## **Central Planning Authority**

**Agenda** for a meeting of the Central Planning Authority to be held on April 13, 2021 at 10:00am, in the 2<sup>nd</sup> Floor Conference Room at Governor's Square.

**CPA/08/21**

Figure 3: Plan Extract showing the proposed development (Source: Robert Towell Architect Ltd. Jan, 2021)

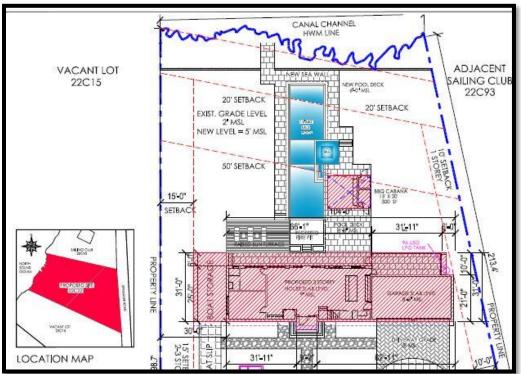
The application plans show the proposed swimming pool being constructed up to the water's edge, as shown in Figure 3.

The Department does not support the request for a setback variance and recommends that the plan is redesigned to take into account the minimum prescribed setbacks for a mangrove coastline (75ft from the MHWM). It is imperative that minimum coastal setbacks are met for all structures including seawalls, pools and pool decks, particularly given climate change predictions for the region and the increasing prevalence of coastal erosion associated with inappropriately sited development too close to the sea. Figure 3 shows that the shoreline is eroding with freshly exposed areas of rock and broken pieces seen in the sea. This highlights the importance of ensuring that setbacks are followed. In order to improve the stability of this shoreline, the applicant could plant red mangroves along the shoreline which will help to bind and stabilise the sediment along the coastline. The DoE can provide further guidance on mangrove replanting.

- Any stockpiled materials should be kept away from the edge of the North Sound to reduce the possibility of rainwater runoff washing material into the North Sound.
- The seawall construction area shall be fully enclosed with silt screens to contain any sedimentation or debris arising from construction of the seawall as depicted by the submitted site plan;
